KIT453 PRELIMINARY INSTALLATION INSTRUCTIONS

SOLID STATE AND BIAS OFF

KIT 453

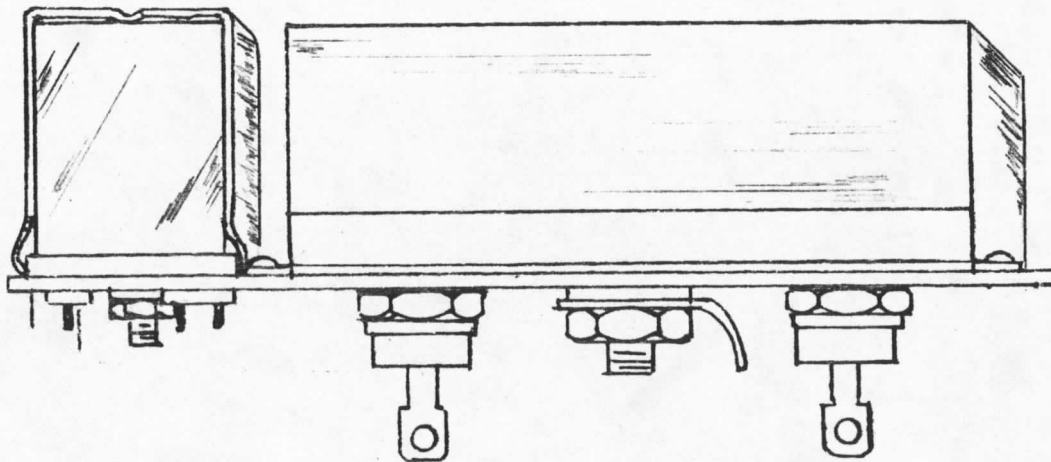
The Technical Materiel Corporation offers a solid state replacement kit (Kit 453) for its AN/FRT-39 and the AN/FRT-93 transmitters. Kit 453 is designed to replace two (2) OA2 voltage regulators, and the 6X4 rectifier both of which are used in the AX104 power supply compartment of the AN/FRT-39 transmitter. This kit also introduces a "BIAS OFF" mode of operation.

- 1) Replaces 6X4 rectifier tube and (2) OA2 bias regulators with solid state devices. These solid state devices will increase the long term reliability of the transmitters.
- 2) Increases bias voltage, which aides in the control of the quiescent current. This will be helpful when operating with rebuilt 4CX5000A final tubes.
- 3) Adds a "BIAS OFF" mode of operation to the transmitter. This will be a significant contribution in conserving power.

KIT 453
BIAS OFF

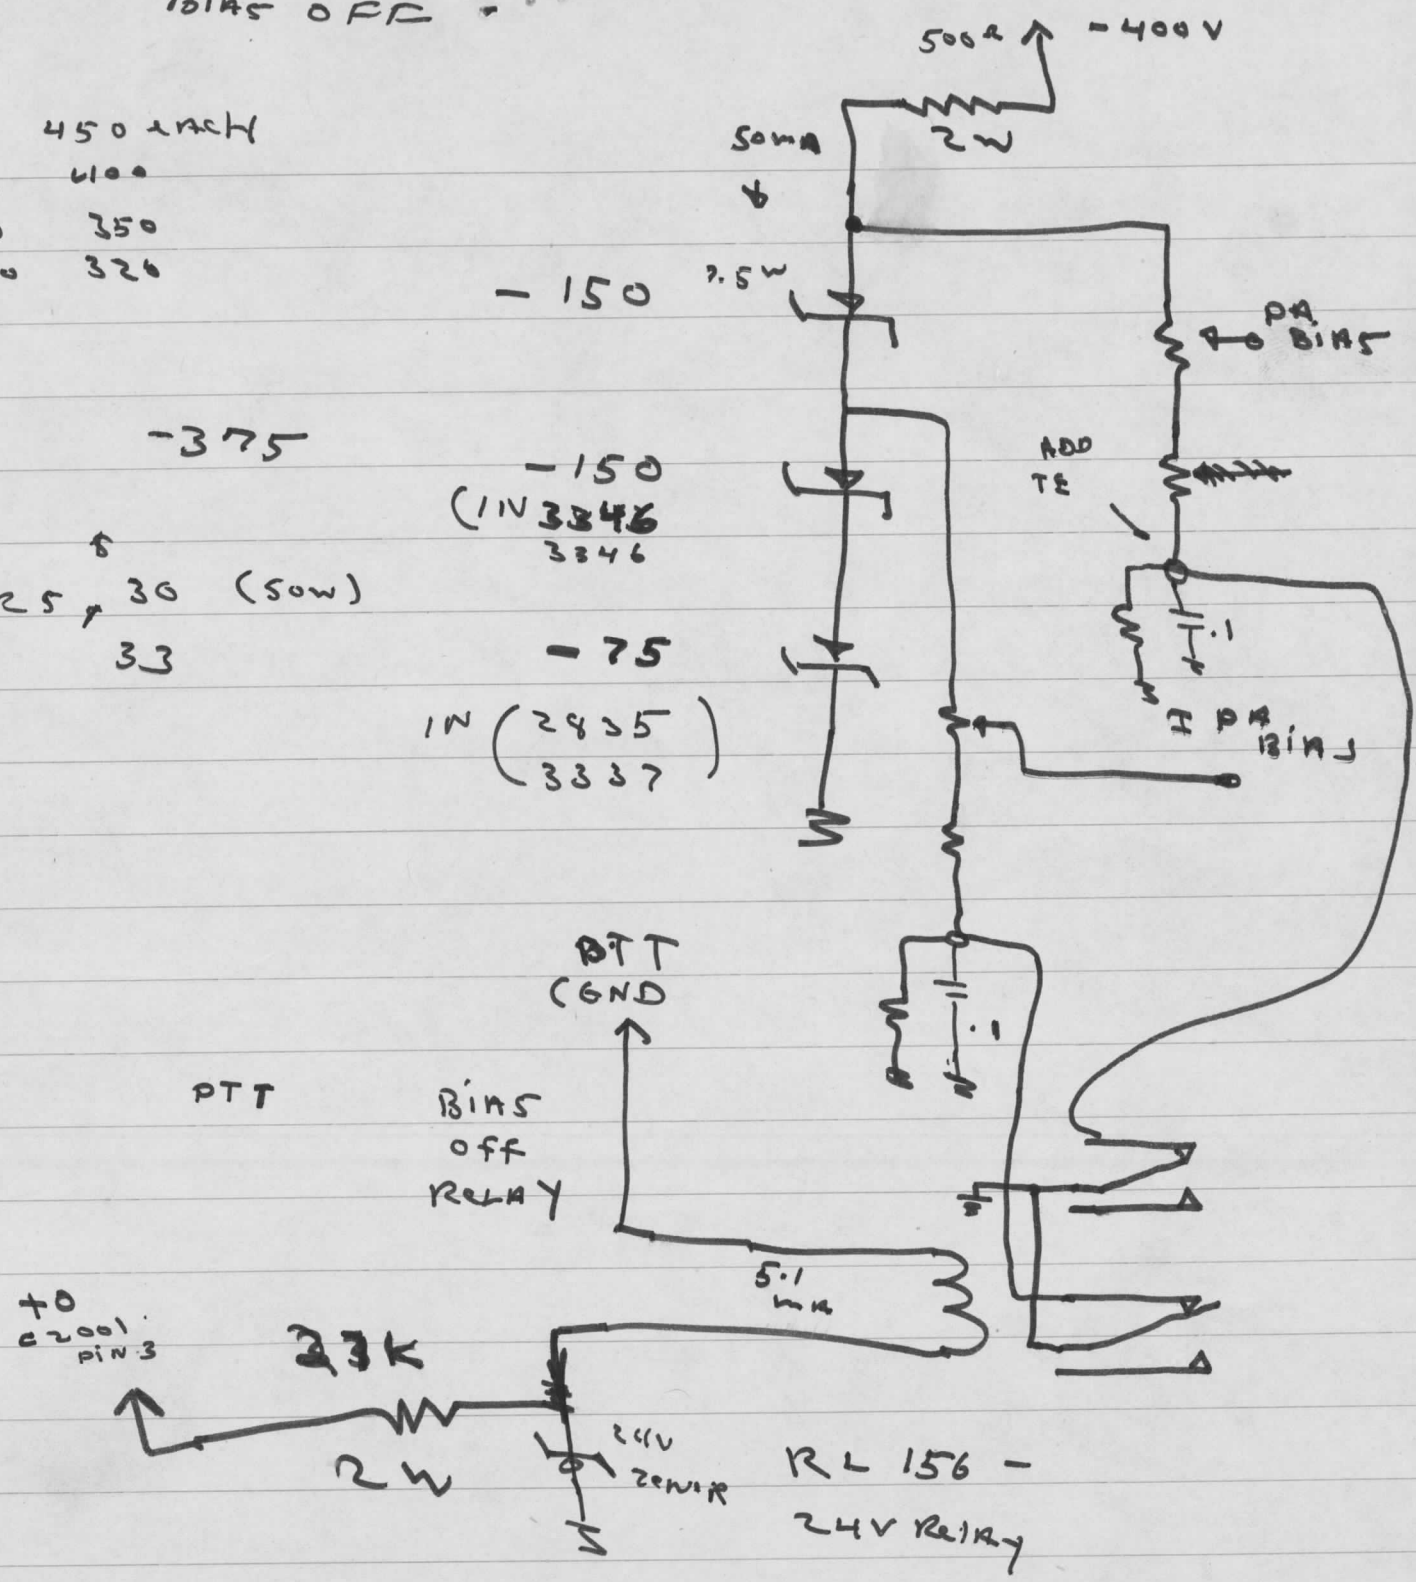
Replace 6X4 with Solid state device (1N 490)

Replace OA 2^s with Solid state devices and Relay

TO WORK in conjunction w/ MMX-C
